PROJECT DESCRIPTION: Site Description

FINDINGS: For Site Plan Review

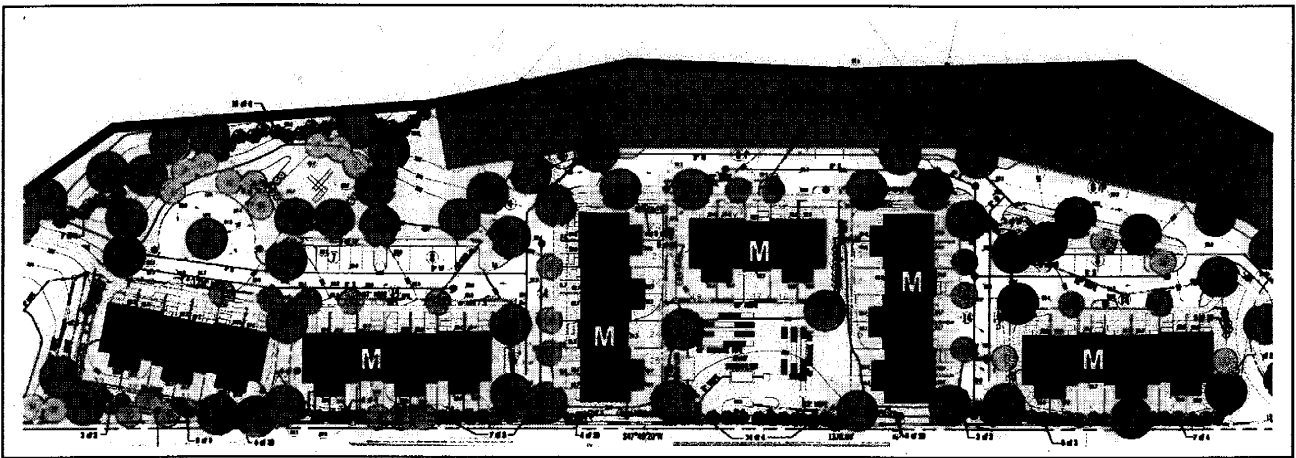
The placement of the buildings identifies a simple massing pattern: A central core, flanked by two “wings,” lines of townhouses that extend the reach of the massing to the east and west. The single loaded drive follows almost exactly the SHA boundary, terminating in a landscaped cul-de-sac at the western site boundary. The smaller clusters, set with rear lots against the south property line and existing Tanglewood neighborhood, establish a the strong building line—orienting the subdivision in relation to the berm that forms the northern boundary. Thus, the resulting scheme clearly illustrates the limitations imposed by the SHA taking, revealing the limited “slice” of land area available for creating a residential community.

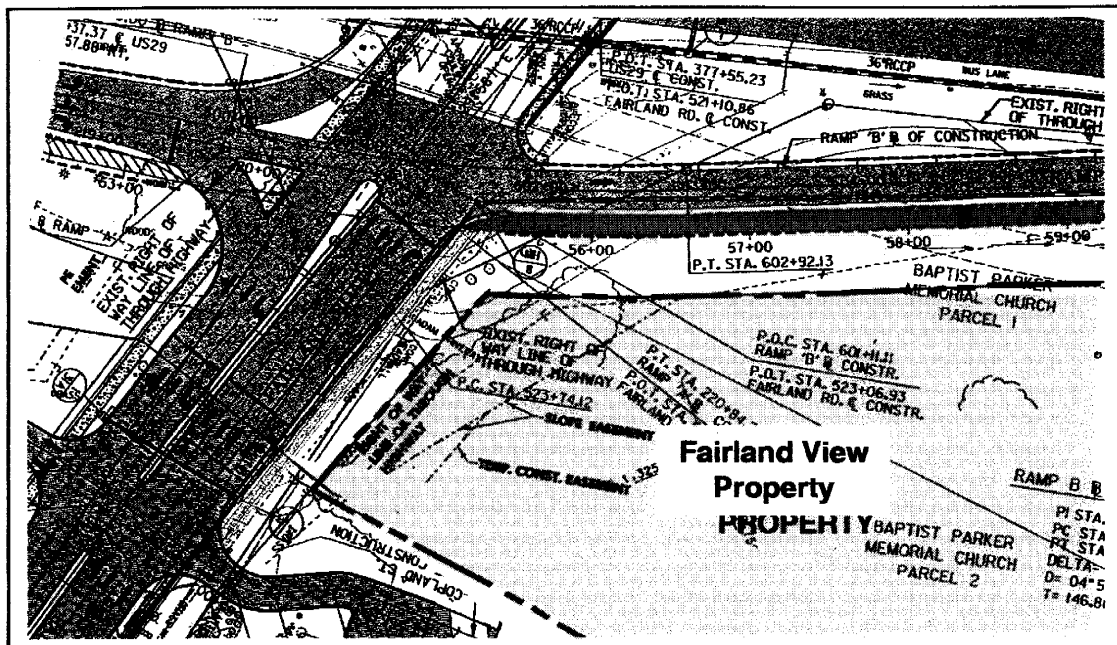
and ornamental trees. A mixture of evergreen, ornamental and shade trees are proposed for the Fairland Road frontage; however, staff recommends that formal street trees be provided along the road frontage with the sidewalk, subject to DPWT or SHA approval.
